Service Bulletin

Bulletin No.: PI1013A

Subject: A/C Blows Warm Air Intermittently

Models: 2013 Chevrolet Spark

2754800

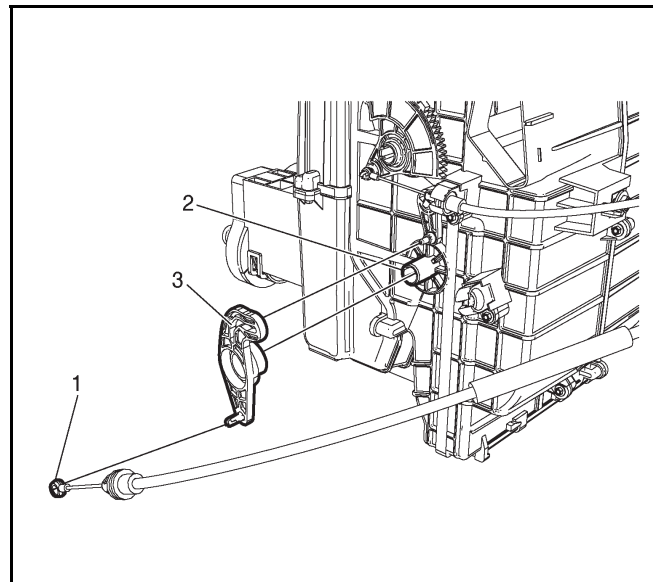
1. Replace the **WHITE** temperature cam link (3) shown in the illustration above with a black colored cam link. Refer to Temperature Valve Link Replacement in SI.

3516909

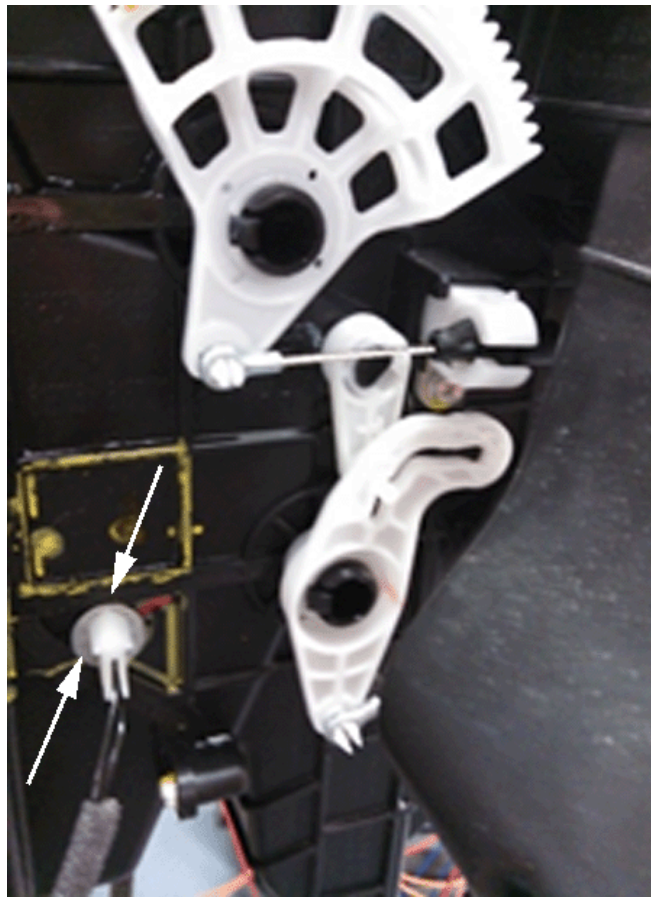
2. Remove the (EAT) sensor by turning the top of the sensor left and pull out.
3. Disconnect the wiring connector from the sensor.
4. Install the new sensor with the arrow at the 9 o'clock position, then turn right to the 12 o'clock position.
5. Connect the wiring connector.

Note: To determine if a new EAT sensor has already been installed, the new EAT sensor will be bent upwards and to the left of the base arrow. The new sensor in natural in color.
